19 November 2026

SUBJECT: **Addendum Number 1**
Town of Jamestown
JAMESTOWN PARK - Natures Call Park Restrooms
Jamestown, NC

FROM: Ramsay, Burgin, Smith Architects, Inc.
225 North Main Street, Suite 501
Salisbury, NC 28144

A1-01 FLOOR PLAN

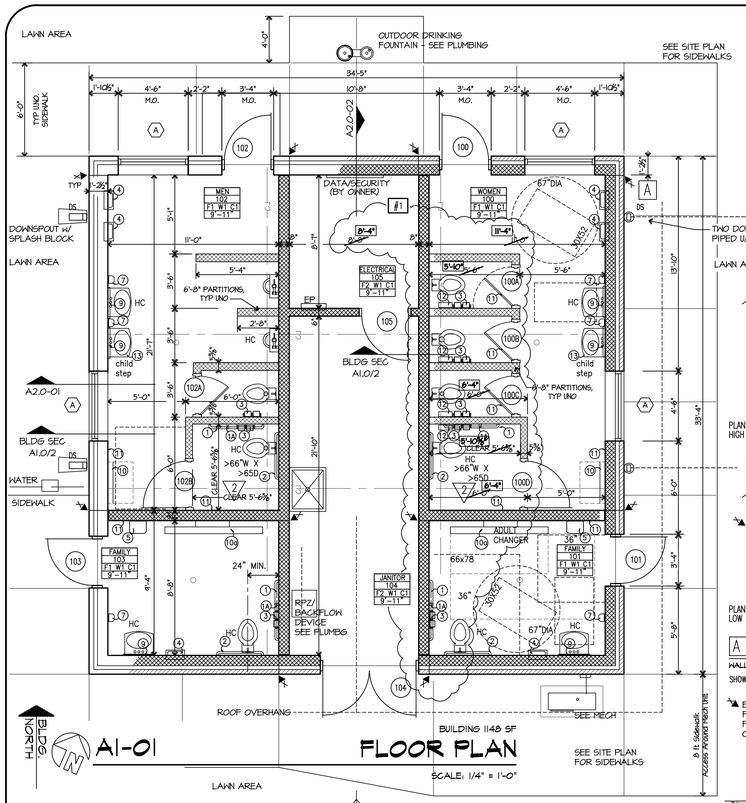
Item 3- **See Attached Revised Sheet A1 Plan, Elevations & Details.**
Reference A1-01 Floor Plan. **SHIFT west wall of Women 100** to increase width of room by 4 inches and reduce width of Janitor 104/Electrical 105 by 4 inches. The entire 4 inches to be added to the depth of the Women's Stall making it 5'-10" deep in lieu of 5'-6" deep and making the Women's HC Stall 6'-4" deep in lieu of 6'-0" deep.
The Men's Restroom dimensions remain unchanged.
Reference A1-02 Building Section revised per Floor Plan. Women's Restroom increased to 11'-4" and Janitor decreased to 8'-4". Section Revised to include proposed Waste Lines and approximate depth of line(s) at exit of the Building Footprint - requiring STEP in footing.

#1 ADDENDUM #1 - SHIFT WEST WALL OF WOMEN'S RESTROOM.
CMU WALL SHIFTED TO INCREASE WIDTH OF WOMENS RESTROOM BY 4 INCHES AND REDUCE JANITOR/ELEC ROOMS BY 4 INCHES. ENTIRE 4 INCHES ADDED TO DEPTH OF WOMEN'S TOILET STALL AREA.
UNDERSLAB PLUMBING/WASTE ROUGH-IN. COORDINATE DEPTH OF WASTE LINES AND STEP FOOTING WHERE WASTE EXITS BLDG.

ADDENDUM #1 Item #5

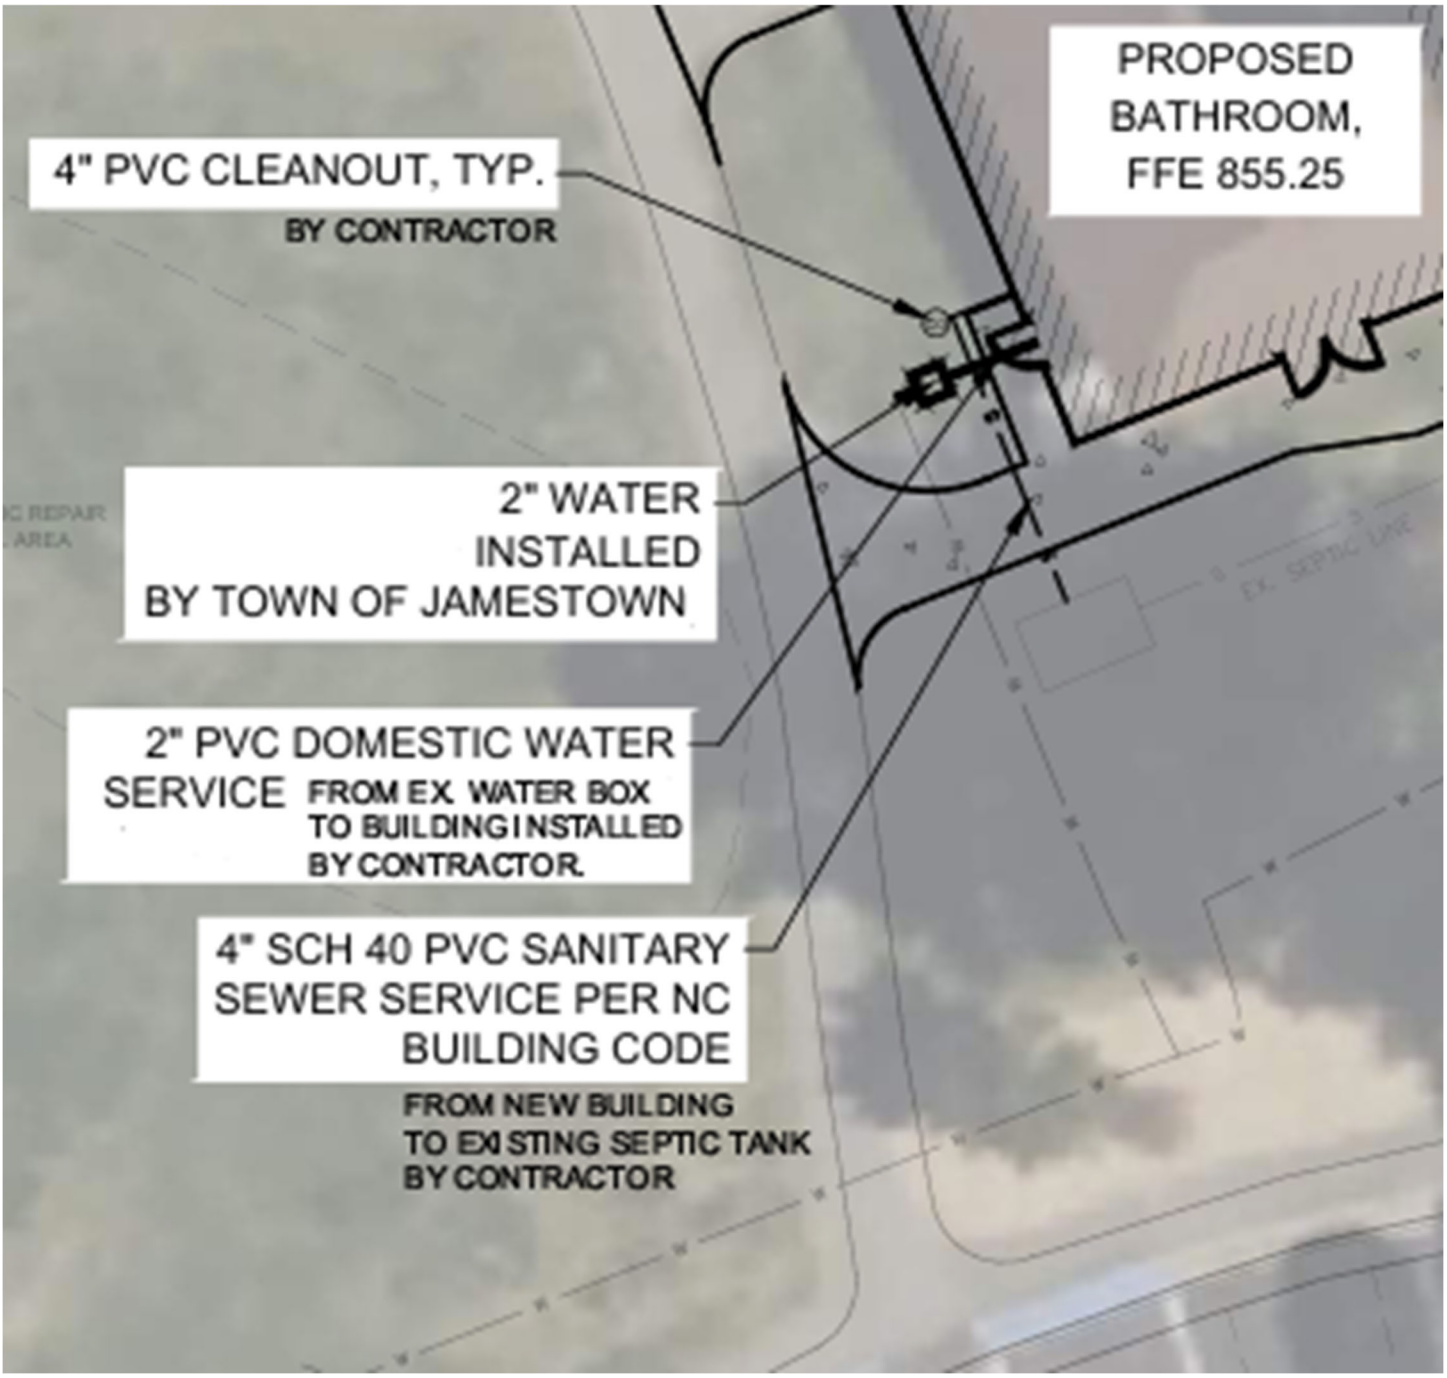
Item 5- Reference C-3 Utility Plan. **See Attached Bulletin** for clarification of scope of work on both Water and Sewer for the New Restroom Building. Note that the existing Water Line and Septic System (tank and drainage field) must be protected during the construction process. If services are damaged by contractor, they must be repaired by contractor.

REFERENCE CIVIL SHEET C-3 UTILITY PLAN
